Application no: 20/03353/OUT

Location: Land West of Cotefield Business Park Oxford Road Bodicote

Following you letter dated 7th of January 2020, we respond to your queries below.

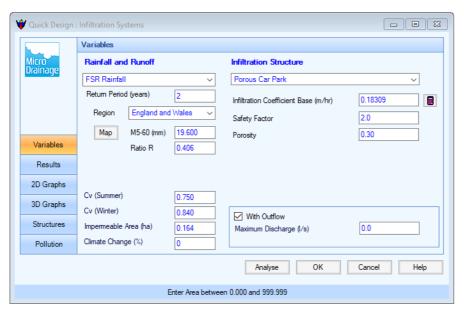
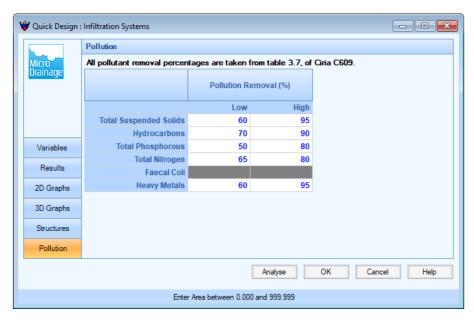
Query 1: The application must supply more details on the proposal. As the site lies within Groundwater Vulnerability Zone and includes parking spaces, water quality assessment must be carried out. The water quality assessment must be in accordance with Section 4 and Section 26 of SuDS Manual. Proposed development must meet local standards, L19, "At least one surface feature should be deployed within the drainage system for water quality purposes, or more features for runoff which may contain higher levels of pollutants in accordance with the CIRIA SuDS Manual C753. Only if surface features are demonstrated as not viable, then approved proprietary engineered pollution control features such as vortex separators, serviceable/ replaceable filter screens, or pollution interceptors may be used"

Response: The new surface water drainage proposals are shown on the drainage strategy drawings. The surface water from the roofs goes through the RWP and then goes to the surface water pipe network. These drains in turn discharge to the sub-base of the car park area via a water distribution chamber. All the flow is infiltrate into the ground using the sub-base of the car park area.

The permeable surface will remove the soils and provide a water treatment to the surface water. See below print screen of the treatment capacity of the permeable sub-base. We conclude that the proposed SuDS train provides a good treatment of surface water.
